Access Compliance Report

Public Rights-of-Way

(Curb Ramps)

Intersection ID: 3448	Main Street: W W T HARRIS BV TO I-77 RA SB	Location: NE
ADA ID: F32F06A72587	Ramp Type: Para	Initial Pass/Fail: Fail
	Overall Compliance: No	Severity Score: 13.75
Codes/Mitigation Info/Possible Solution		Field Measurements/Component Compliance

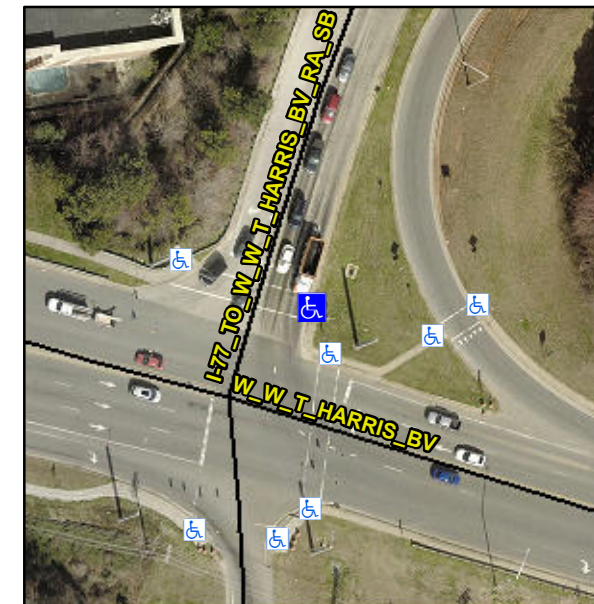
LT RP < 5%

R304.3.2, R304.5.3

Compliance	Description	Data	Compliance	Description	Data
N/A	Ramp Length LT (in)	60.0	N/A	Ramp Length RT (in)	60.0
Yes	Ramp Width LT (in)	60.0	Yes	Ramp Width RT (in)	60.0
Yes	Ramp Slope LT (%)	3.4	No	Ramp Slope RT (%)	9.1
Yes	Ramp XSlope LT (%)	2.0	No	Ramp XSlope RT (%)	2.5
N/A	Landing Length (in)	N/A	N/A	DWS Provided?	N/A
N/A	Landing Width (in)	N/A	N/A	DWS Contrast?	N/A
N/A	Landing Slope (%)	N/A	N/A	DWS Length (in)	N/A
N/A	Landing X Slope (%)	N/A	N/A	DWS Full Width?	N/A
N/A	Landing Curb? (Y/N)	N/A	N/A	DWS Offset (in)	N/A
N/A	Shared Landing?	N/A			
N/A	Gutter Ponding?	N/A	N/A	Gutter Slope (%)	N/A
N/A	Gutter Lip Ht (in)	N/A	N/A	Gutter X Slope (%)	N/A
N/A	Painted X Walk1?	Yes	N/A	Painted X Walk2?	N/A
	X Walk 1 Direction	To NW		X Walk 2 Direction	N/A
N/A	X Walk 1 Width (in)	136.0	N/A	X Walk 2 Width (in)	N/A
	X Walk 1 Slope (%)	1.7		X Walk 2 Slope (%)	N/A
	X Walk 1 X Slope (%)	1.2		X Walk 2 X Slope (%)	N/A
N/A	Ramp inside XWalk1?	Yes	N/A	Ramp inside XWalk2?	N/A

Remove & Replace Entire Ramp.
